Parkscene Bangladesh Ltd

Mouza Kunia . JL No,. 406, Gazipur Sadar. Gazipur

(23.934767N, 90.387349E)
20th April 2014

Observations

Heavy Loading on Slabs

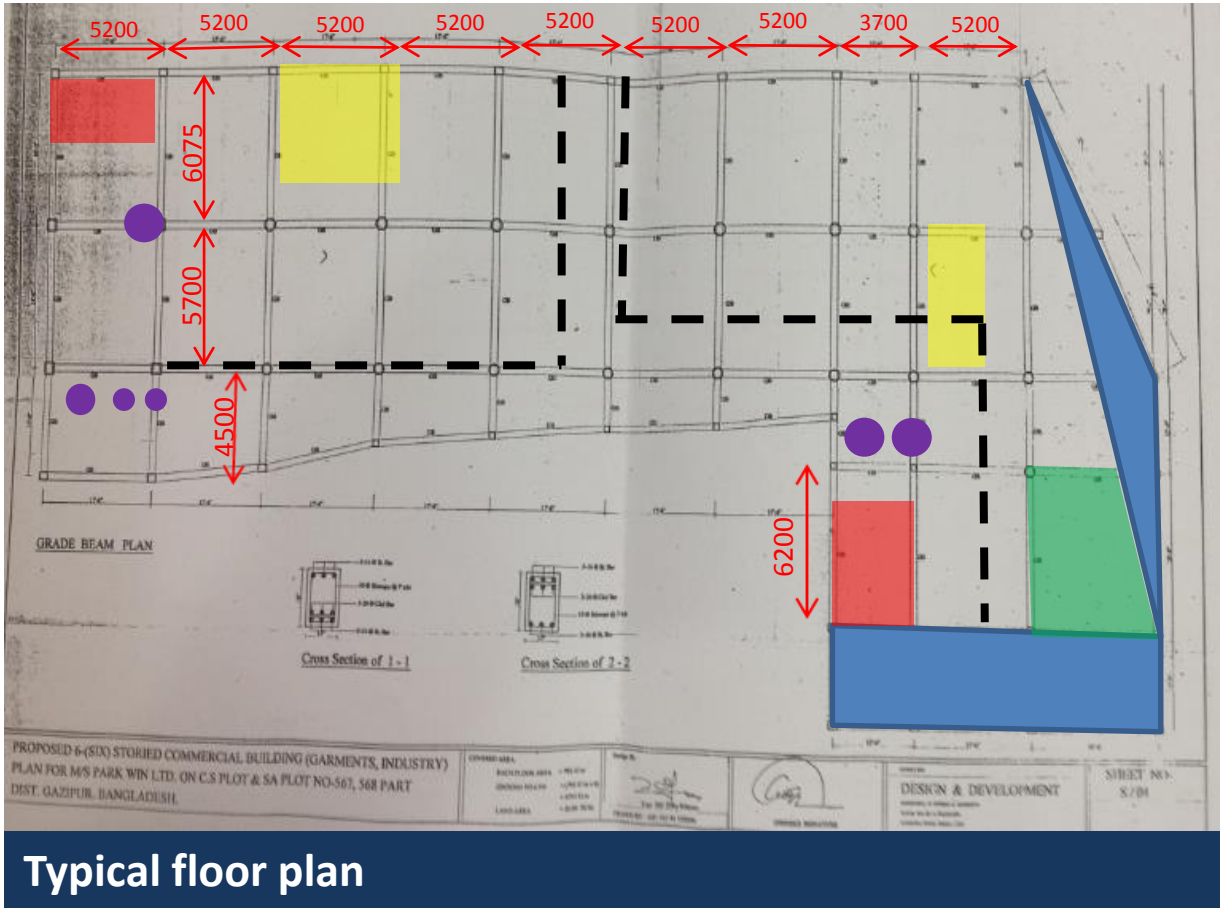
Heavy loading was observed in several locations on floor and roof slabs:

- Water tanks on the roof slabs above stairs
- Toilet areas
- Storage areas
- Masonry partition walls at 2nd Floor

Heavy dead load due to toilet build-up

5 kN/m²
estimated live load

2 kN/m estimated
superimposed dead load

Non-Permitted Additional Storey

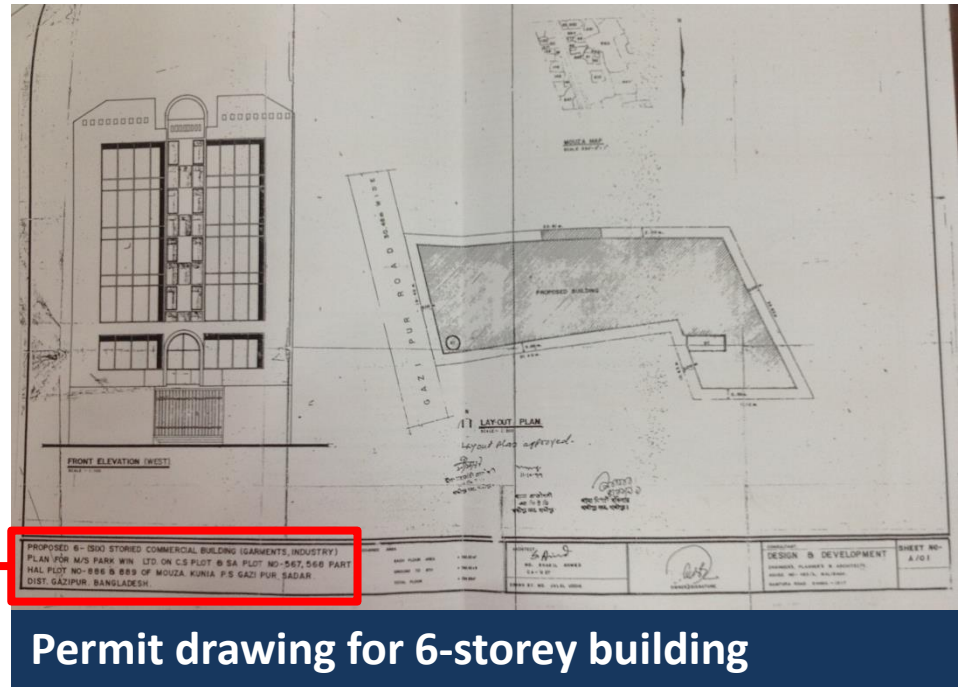
A shed roof has been erected over the former R.C. roof to create a usable floor space at the roof level (6th Floor), so the building now has seven (7) occupied storeys. The Building Permit is for a 6-storey building. The 6th Floor is currently being used for sewing and prayer, and it has also been used for dining.

Item No.	Observation	Recommended Action Plan	Recommended Timeline
10	Heavy loading due to build up of material in toilets	As part of the DEA (see Item1)Engineer to carry out calculations to justify floor slab in the area of the toilets. Large build up of load noted as a result of raised floor	Immediate - Now
11	Heavy loading due to build up of material in toilets	Complete assessment	6-weeks
12	Heavy loading due to build up of material in toilets	Carry out alterations as a result of the engineering study	6-months
13	Non – permitted additional storey and associated non engineered structure	As-built documents to be completed as part of DEA	6-weeks
14	Non – permitted additional storey and associated non engineered structure	Engineer inspect and design and detail remedial works	6-weeks
15	Non – permitted additional storey and associated non engineered structure	Carry out remedial works as required	6-months

Crack in Wall Panel between Roof Trusses

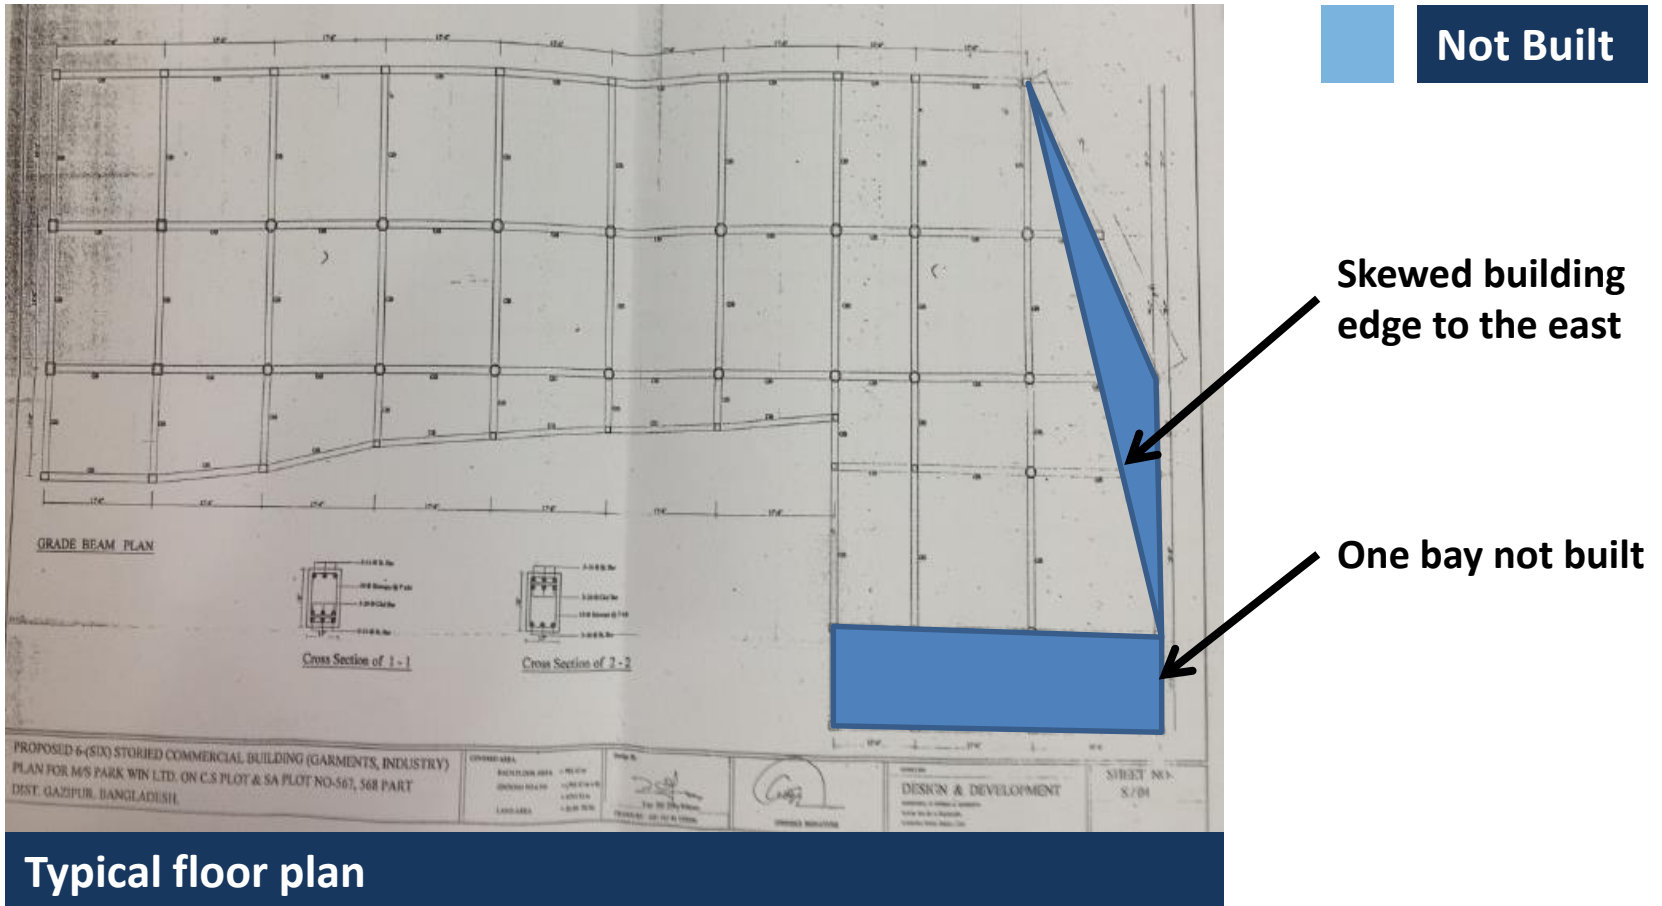
A crack was observed in the masonry wall panel below a window between the roof trusses at the 6th floor.
This was an isolated area

Crack in wall panel

Heavy loaded columns

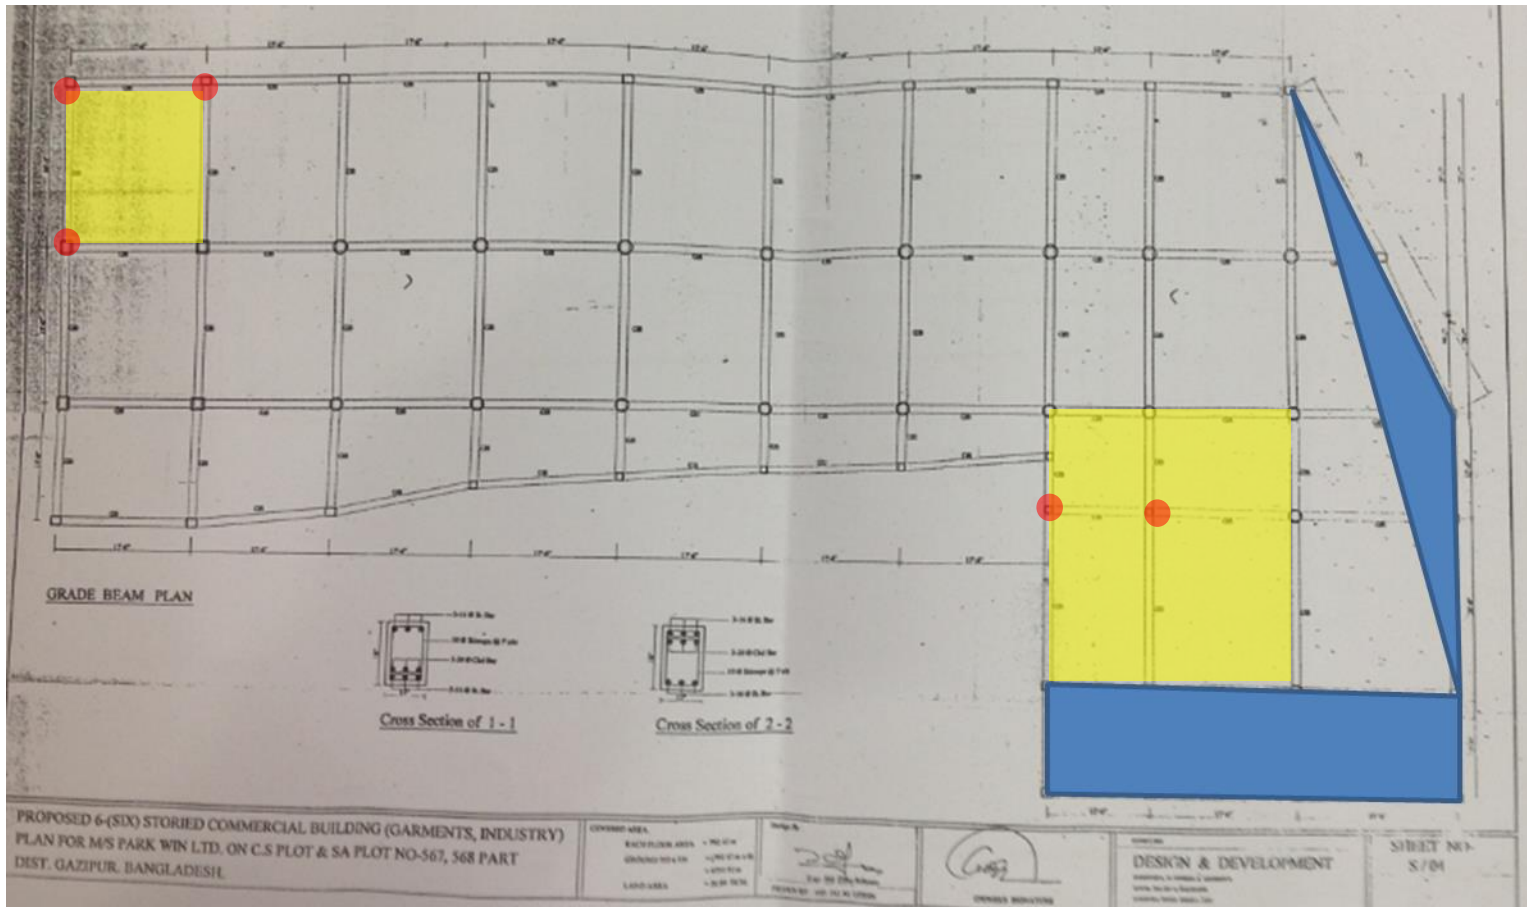
- Heavy Loaded columns
- Area where loading is not to exceed 1.0kN/m² prior to completion of DEA

Item No.	Observation	Recommended Action Plan	Recommended Timeline
1	Heavily loaded columns in toilet areas	Live load to be controlled as per limits on following page	Immediate - Now
2	Heavily loaded columns in toilet areas	Detail Engineering Assessment of as-built structure to be commenced as per attached scope.	Immediate - Now
3	Heavily loaded columns in toilet areas	Verify insitu concrete strengths (using min. 4 no. 100mm dia. Cores and/or assessment of available concrete strength data) and existing reinforcement for all columns	Immediate - Now
4	Heavily loaded columns in toilet areas	Detail Engineering Assessment to be completed	6-weeks
5	Heavily loaded columns in toilet areas	Produce and actively manage a loading plan for all floor plates within the factory giving consideration to floor capacity and column capacity.	6-weeks
6	Heavily loaded columns in toilet areas	Make alterations to the toilets as required.	6-weeks

7	Heavily loaded columns in toilet areas	Continue to implement load plan for all floor plates within the factory.	6-months
8	Heavy loading noted in isolated areas of some floor plates	Building engineer to produce loading plans to be displayed at each floor level.	6-weeks
9	Heavy loading noted in isolated areas of some floor plates	Factory manager to actively manage floor usage in accordance with the loading plan.	6-months
